MFN 06-215

Docket No. 52-010

**Subject: Response to Portion of NRC Request for Additional Information
Letter No. 33 Related to ESBWR Design Certification Application –
Engineered Safety Features – RAI Numbers 6.2-48 through 6.2-51,
6.2-53 through 6.2-57, and 6.2-64 through 6.2-74**

MFN 06-215

Figure 6.2-72_a Feedwater Line Model for FWL Break Analysis

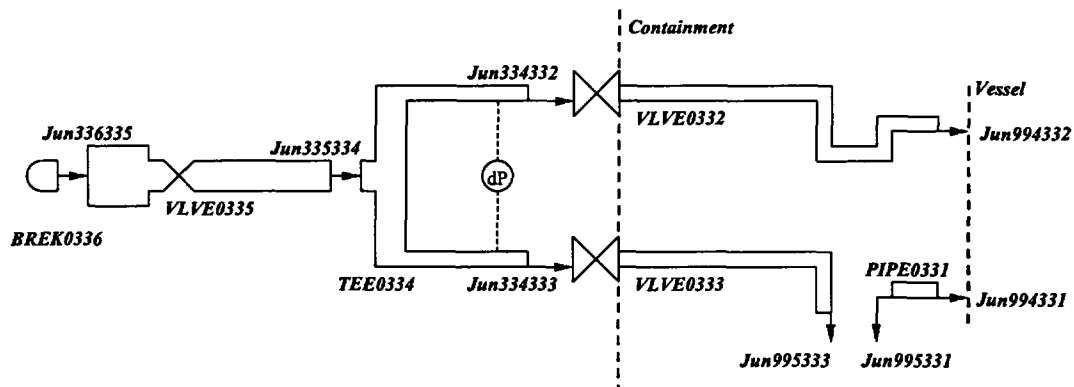
Systems are identified as part of the DCD version of the TRACG model, but are not shown in the nodal scheme, therefore a more complete nodalization should be provided, including, for example, the ICS, SLCS and the feedwater system. Include this information in the DCD Tier 2.

The TRACG nodalization schematic diagrams for the ICS and Feedwater system are shown in the following two figures. The SLCS is simulated via a FILL component (FILL0037) that injects boric liquid into the RPV at the mid-elevation of the outer bypass (RPV axial Level # 5, Ring # 3).

Figure 6.2-74 IC/PCC Pools Configuration

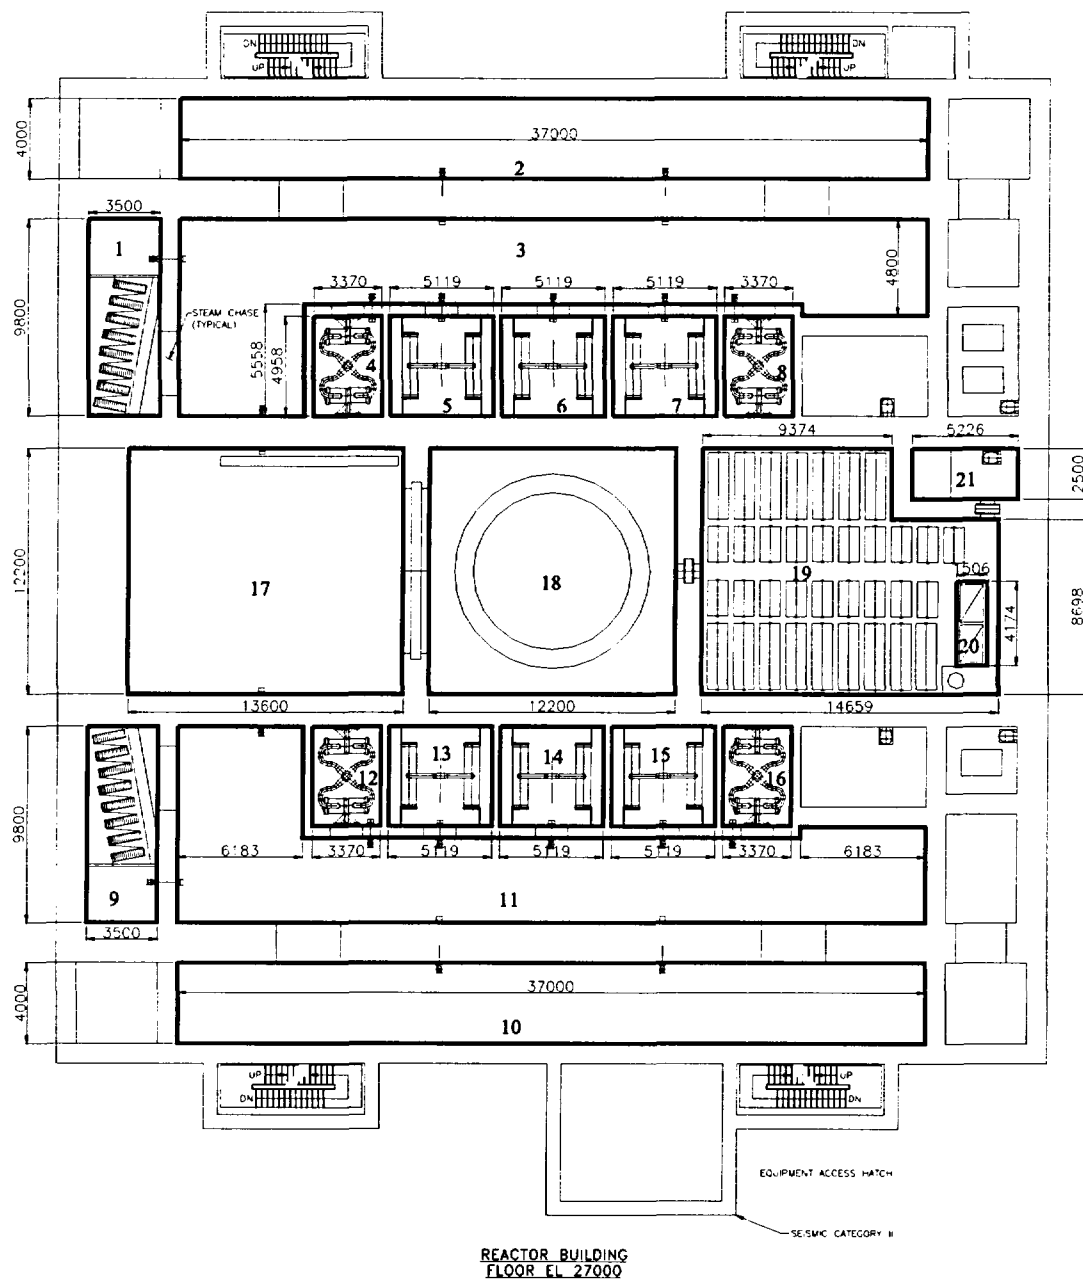
Provide a description, and drawings, of the PCCS and ICS upper pool volumes per unit (m3) with the location (elevation in meters) and areas (m2) of connective pathways, and other connected pool volumes (storage, etc.) with connective pathways.

Figure 6.2-74 shows the plan view of the PCCS and ICS upper pools and Table 6.2-74 summarizes the water volume, water depth and area of these pools. The bottom floor of these pools is located at elevation 27.0 meters from the RPV bottom (0.0 m).

The Reactor Well (Pool # 18) and the Dryer/Separator Storage Pool (Pool # 17) are connected with a large opening during normal operation. The initial water depth of these pools is at 6.7 m, while water depth of other pools is at 4.8 m. There are two valves connecting the Dryer/Separator storage pool (Pool # 17) and the IC/PCC inner expansion pools (Pool # 3 and # 11). These valves are located at an elevation near the pool bottom. These valves are normally closed and will open when the water level in the PCC pool drops below the elevation of 29.6 m. At this elevation, the top ¼ portion of the IC/PCC tubes becomes uncovered.
